North Dakota Department of Transportation

ADDENDUM 1 – JOB 43

TO: All prospective bidders on project IM-8-029(170)033, Job No. 43 scheduled for the November 17, 2017 bid opening.

ADDENDUM 1 JOB 43

STANDARD WOVEN WIRE FENCE

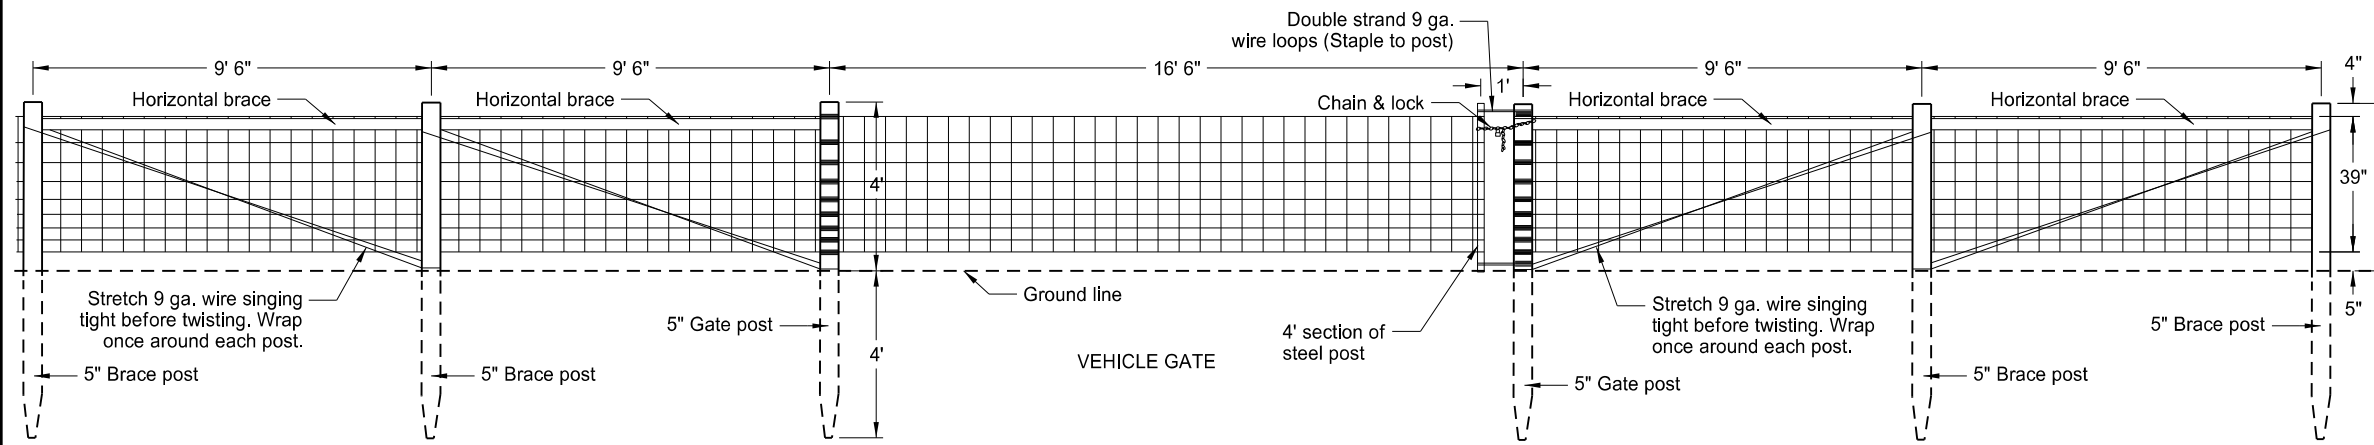
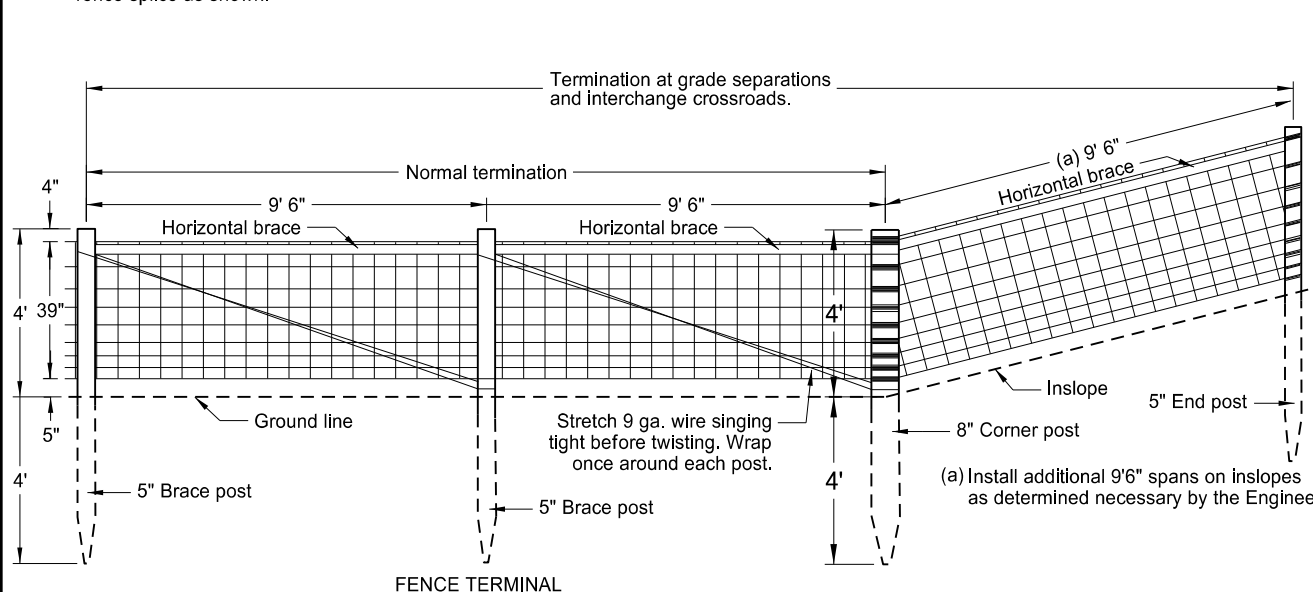
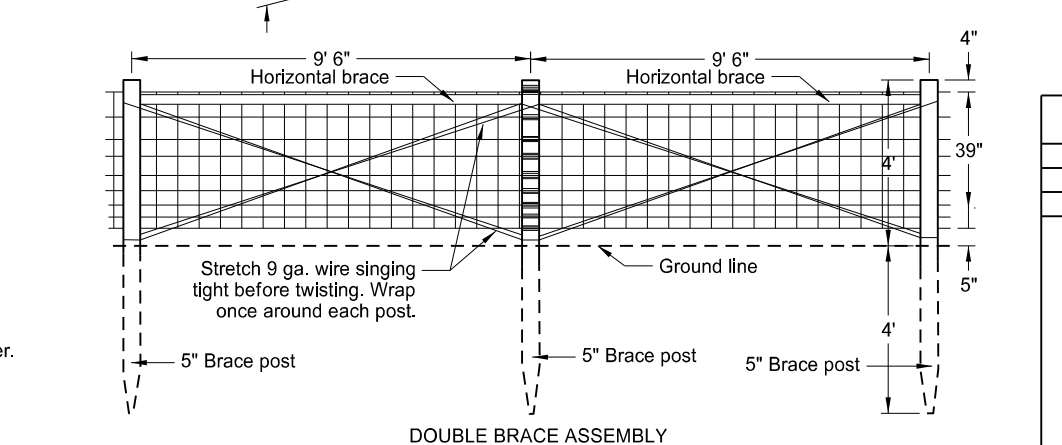
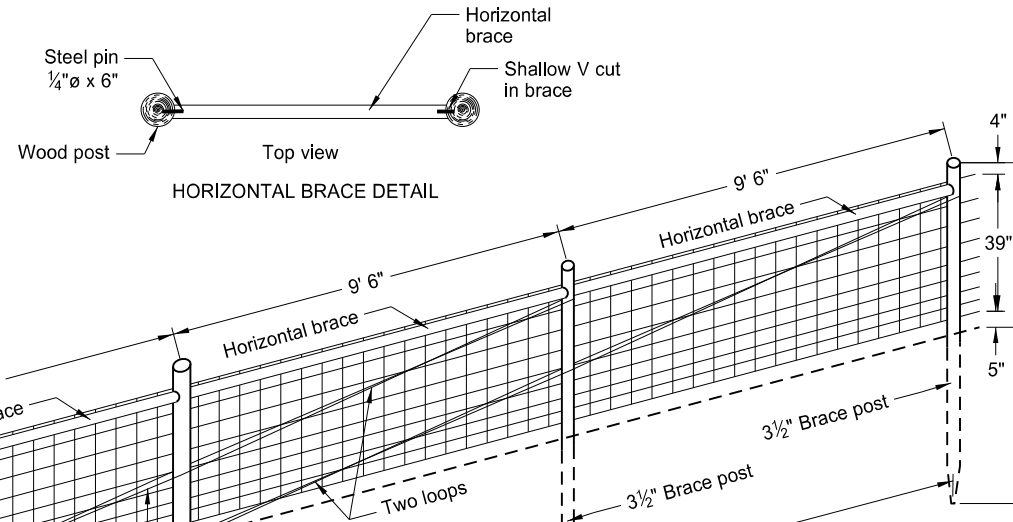
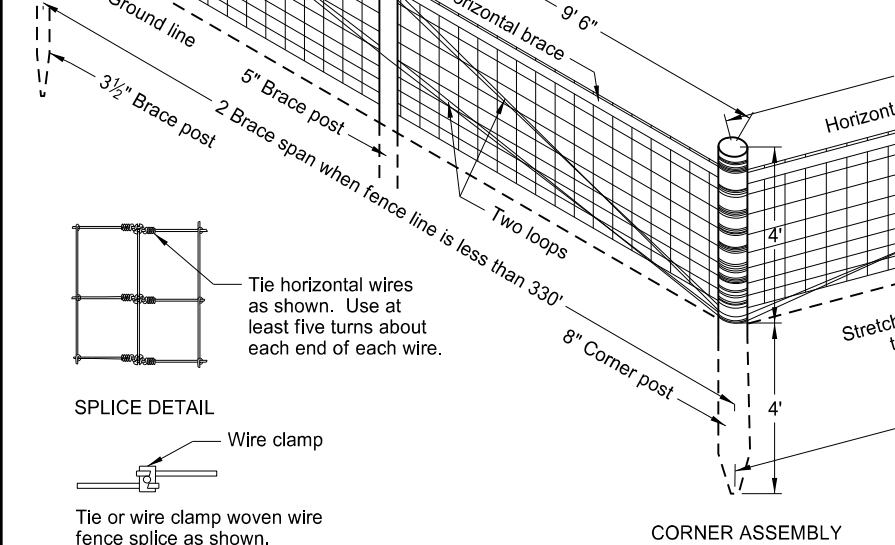
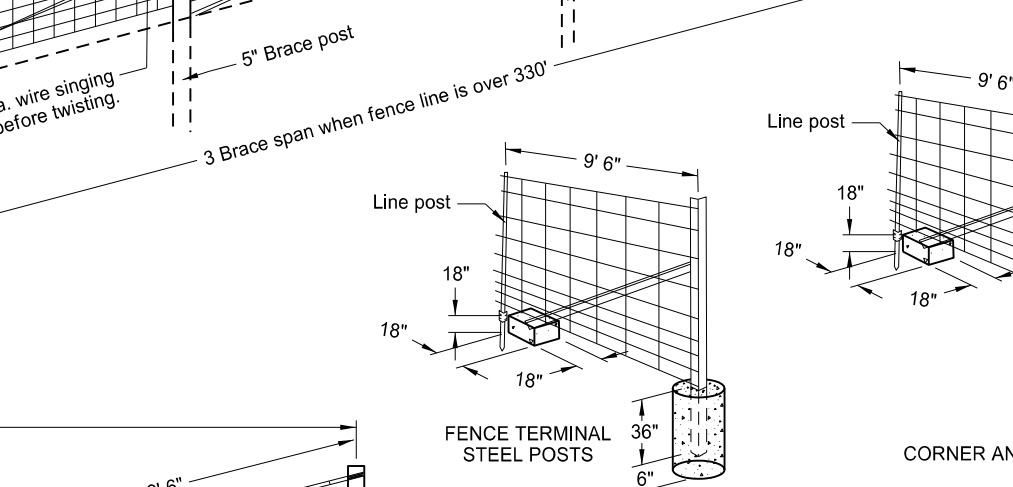
- Added Standard Drawing D-752-3 Standard Woven Wire Fence.
